Technical Service Bulletin

MODEL(S) AFFECTED: Speed Scrub 500 Walk-Behind Scrubber

Squeegee Lift Bracket Spring Guide

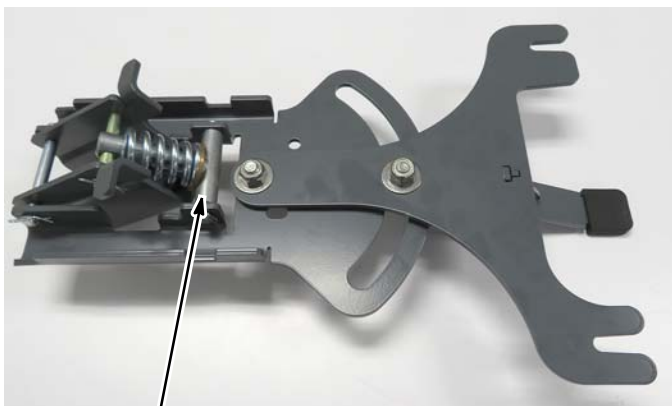
SUBJECT: The bronze spacer located on the squeegee lift bracket spring guide may fail during normal operation over time. If spacer fails (cracks in half), the squeegee blade pressure that is applied to the floor will weaken and cause a reduction in solution pickup. The squeegee pedal may also fail to stay in the up position during transport due a failed spacer.

Bronze Spacer

PURPOSE: To repair or prevent the above issue, order the Squeegee Bracket Spring Guide Kit 9016898. The new spring guide is designed to be used without a spacer.

9016898 Squeegee Bracket Spring Guide Kit Contents

1235860 Spring Guide (no spacer required)
9016897 Installation Instructions

Manufacturing Note: As an interim upgrade prior to implementing the new spring guide into production, two stainless steel washers that equal the same thickness of the bronze spacer (to maintain the proper spring retention) were used as a replacement.

Kit Installation Note: The squeegee lift bracket must be removed from the machine in order to relieve tension on spring for spring guide removal. Follow the installation instructions supplied with kit.
